IMPORTANT SAFETY NOTICE Concerning SPERIAN Warrior SCBA Heads-Up Display (HUD) Cable Connection

December 2, 2008

Figure 1 Old cable assembly.

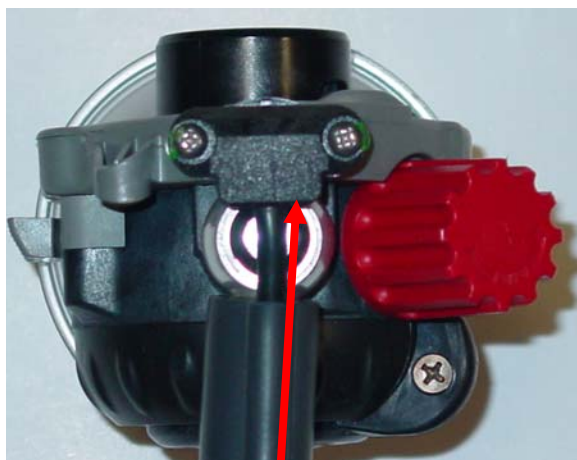
Sperian has determined through examination of some WARRIOR warranty returns that HUD lights did not work correctly. The cause was determined to be the cable assembly that attaches to the HUD. While this condition has been seen on only a few Warriors shipped, and there have been no injuries reported, the cable assembly has been redesigned to eliminate this potential problem. Figure 1 below shows the original cable assembly and Figure 2 shows the new cable assembly. Note that the new cable connector has a rounded edge where the old cable connector had a square edge.

Old connector
Square edge

New connector
Rounded edge

Sperian will replace under warranty the cable assemblies on all WARRIORS that were made with the old cable assembly.

Examine the cable assembly connector and determine if your WARRIORS have the old cable assembly. If they do, contact a Sperian warranty center to arrange to have the cable assemblies replaced. (Note that Sperian technicians certified for Panther repair, but not yet certified for WARRIOR repair, are authorized to perform this upgrade, because the procedure for replacing the WARRIOR HUD cable/hose assembly is the same as for the Panther. They may also run the PosiChek tests necessary to verify this upgrade but may make no further adjustments to the WARRIOR SCBA.)
